SUDAS Revision Submittal Form

Status Date:	As of 8/16/2018	**Topic:**	Linear trench drain
Manual:	Specifications	**Manual Location:**	Section 4020, 1.08, 2.02, and 3.04 Figure 6010.521

LINEAR TRENCH DRAIN

FIGURE 6010.521 | SHEET 1 OF 1

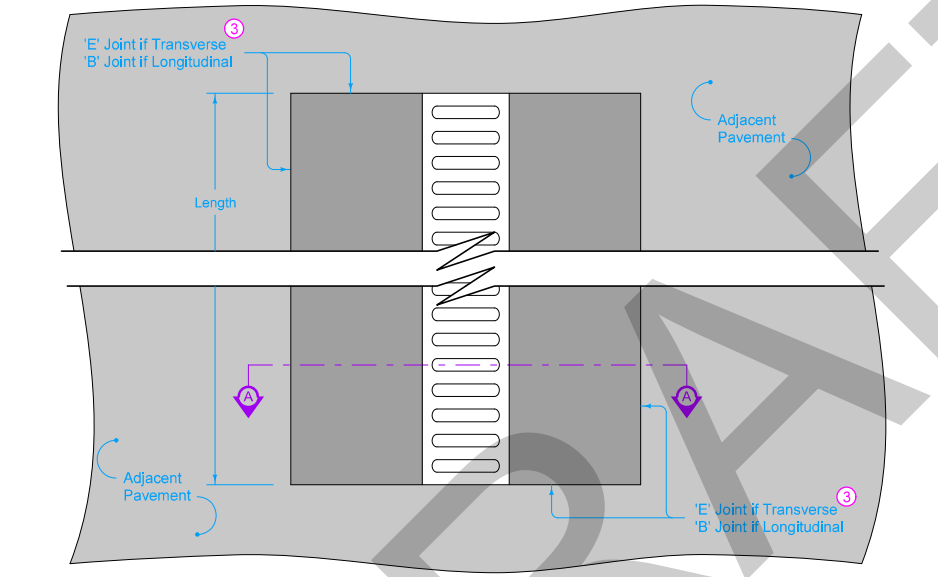
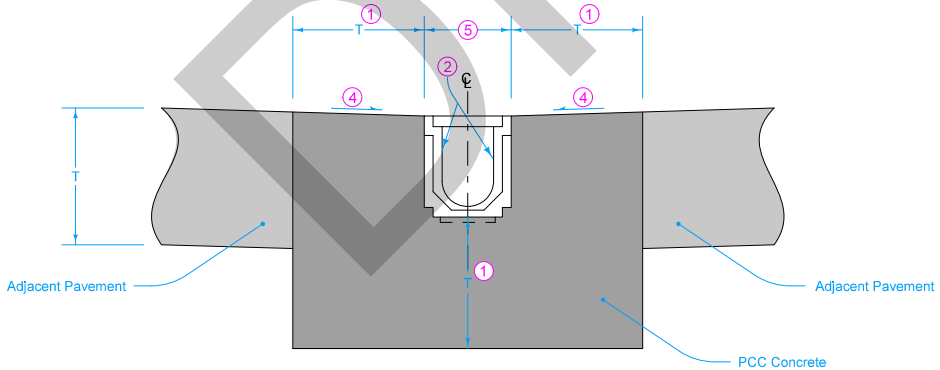
Comply with approved manufacturer's requirements and Iowa DOT Materials I.M. XXX.XXX, as well as in generally complying with Figure 4020.521. Provide certification indicating continuous trench drain meets AASHTO M 306 for 40,000 pound proof load.

Reason for Revision: Added linear trench drain option.

1. Same as thickness of adjacent pavement.
2. Linear Trench Drain.
3. For joint details, see PV-101.
4. Slope same as adjacent pavement.
5. Width as determined by manufacturer.
